**CAMDEN FAMILY HEALTH
WEBSTER COUNTY, WEST VIRGINIA
CAMDEN FAMILY HEALTH ADMINISTRATIVE OFFICES
ADDENDUM #1**

**APRIL 1, 2026
THRASHER PROJECT #T60-11021**

A **MANDATORY** Pre-Bid Conference was held on Wednesday, March 18, 2026, on the above-referenced project, a copy of the sign in sheet is included in this Addendum. The following are clarifications and responses to questions posed by contractors for the above-referenced project.

9 LARGE CONFERENCE ELEVATION
A4.02 1/4" = 1'-0"

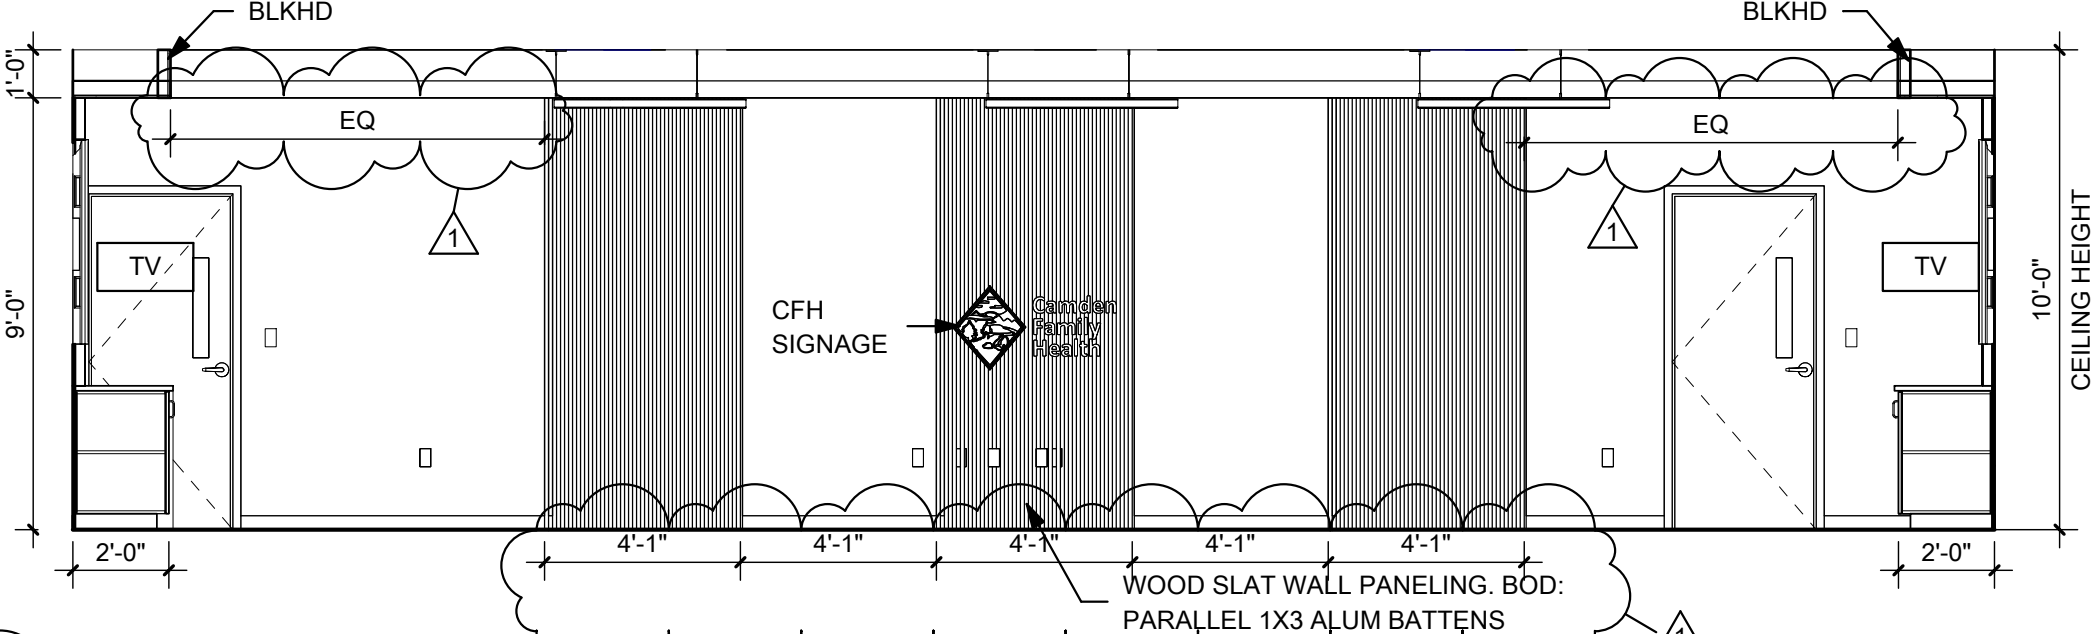
Room 102 on Sheet detail 9/A4.02 shows a Note 3 on the Floor Plan but does not provide Note 3 in the Elevation. Is this correct?

There is no decorative wall covering on the north wall of 102. See attached drawings for more information.

1 SECTION DETAIL - MED RECORDS TRANSACTION WINDOW
A5.02 1" = 1'-0"

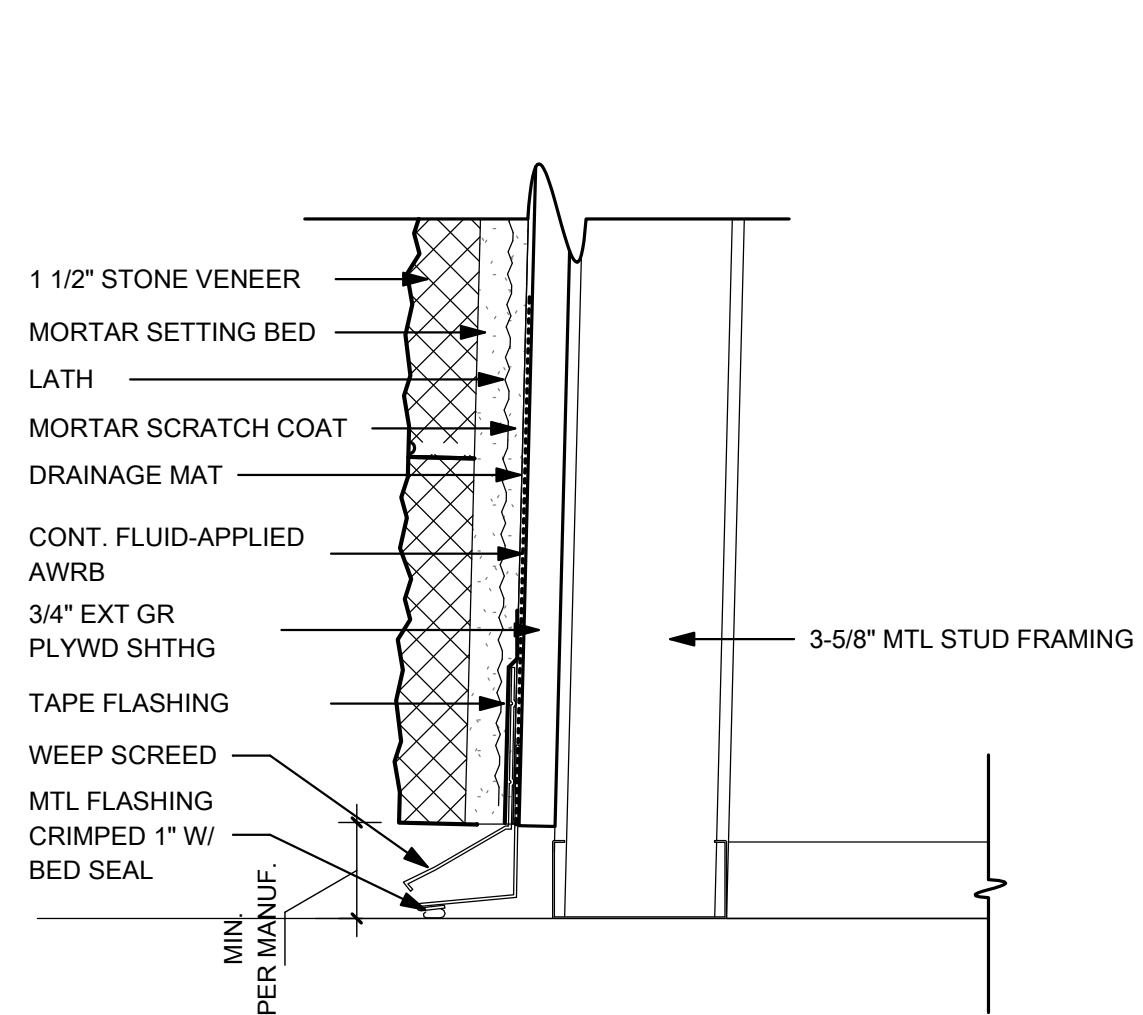
Please show pass-thru window on 1/A6.01 to provide size, frame, and other details in the Window Elevation.

Could a spec or more information (B.O.D) be provided for the transaction window?

See attached drawings.

The basis of design for the window is the CRL Horizontal Sliding "Daisy" Pass-Thru Assembly.

5 MONUMENT SIGN ELEVATION - FRONT & BACK
A7.03 1/2" = 1'-0"

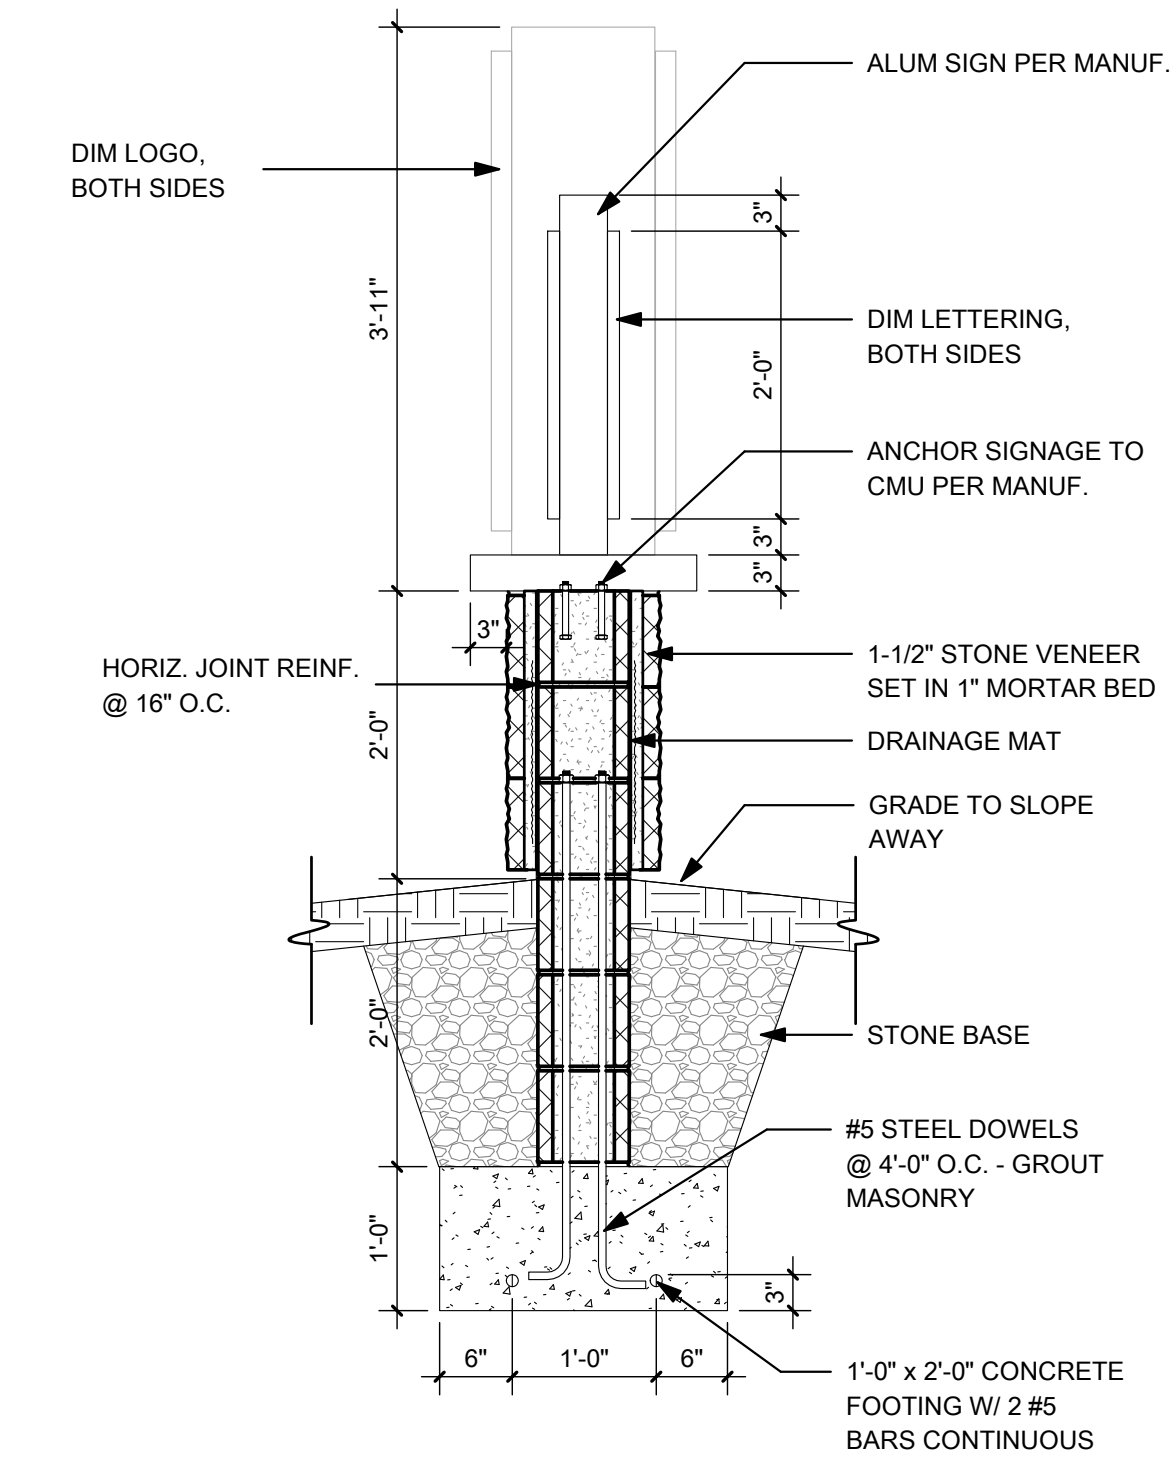
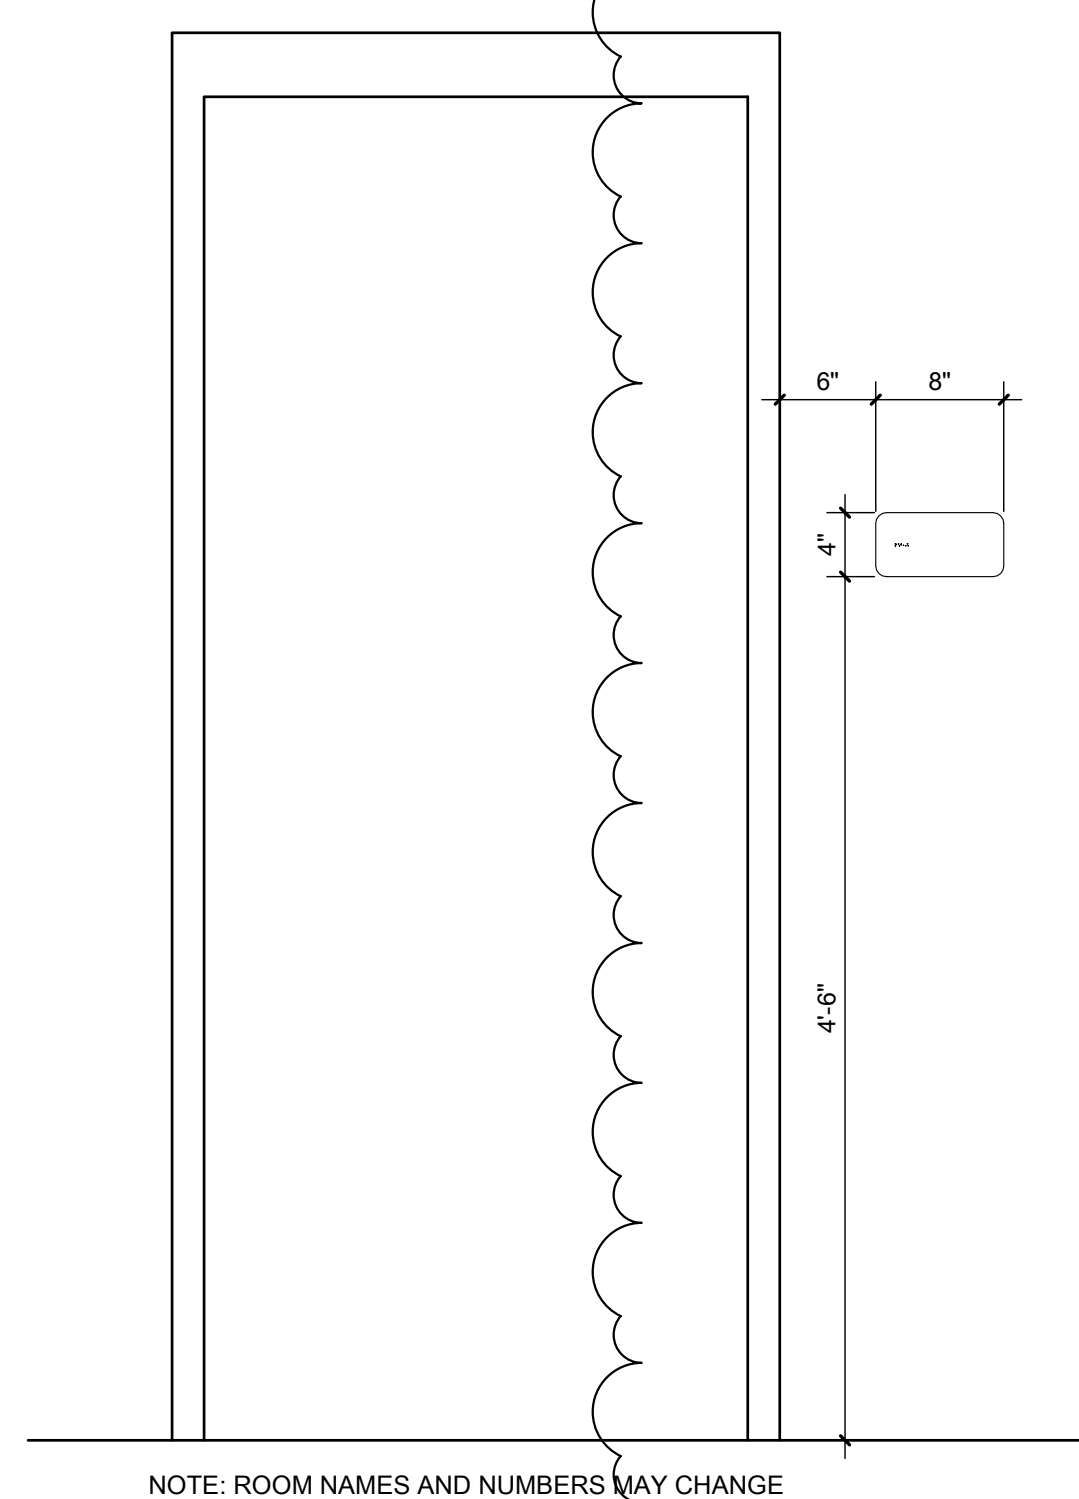
Is there only one Monumental Sign? Sheet E2.03 indicates 2 monument signs.

There is only one monument sign to be centered between the two driveways. See attached drawings for more information.

DRAWN: DATE:
 CHECKED: DATE:
 APPROVED: DATE:
 PROJECT No. T60-11117
 CIVIL SITE PLAN
 SHEET No.

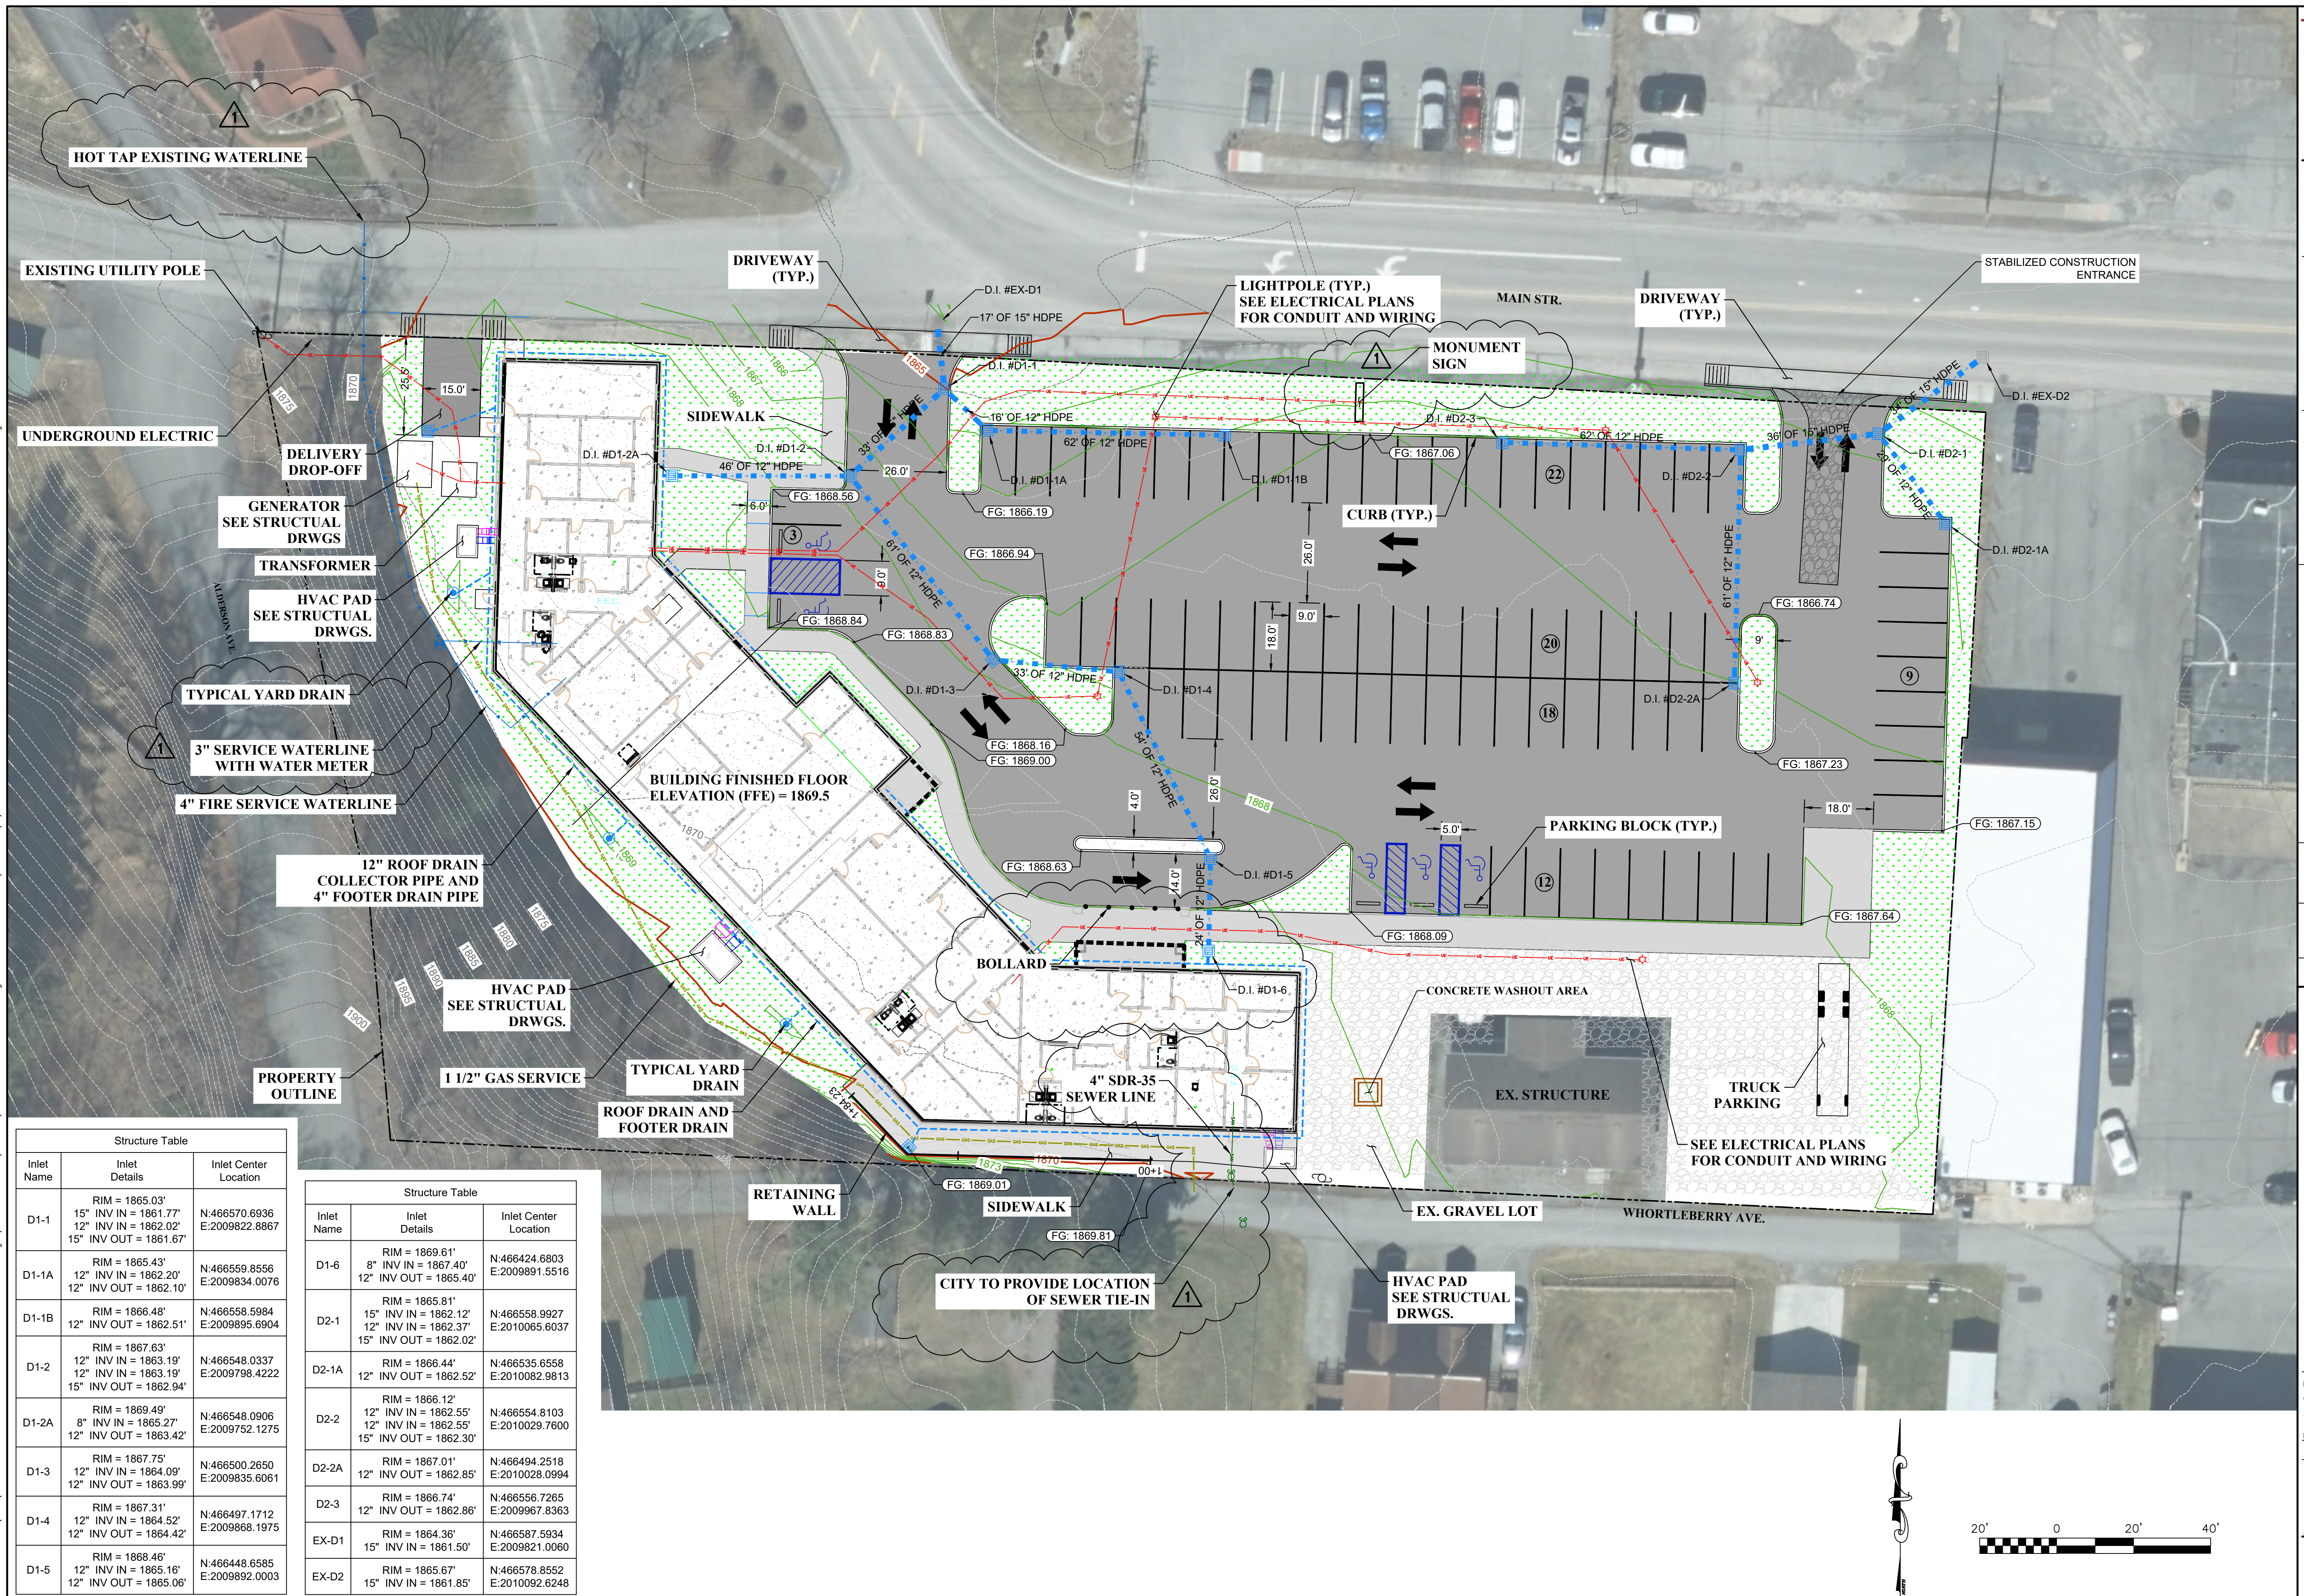
Sheet C2.01 calls out “Driveway (Typ.)” which appears to be an asphalt and sidewalk tie-in. These are located in the green space/graveled area between the property line and existing

What do the dashed blue lines around the building on C2.01 represent?

The Fire Water does not show a Tap Location. Is this correct? Please provide a Tap location.

The driveway (typ.) shall be a 5 foot wide 6” thick concrete sidewalk/drive with a 2”+/- curb.

The dashed blue lines around the building represent a 12" roof drain collector and a 4" footer drain.

The 4" water line that will serve as the fire protection and domestic shall be hot-tapped in the existing public water line as shown in the update sheet C2.01
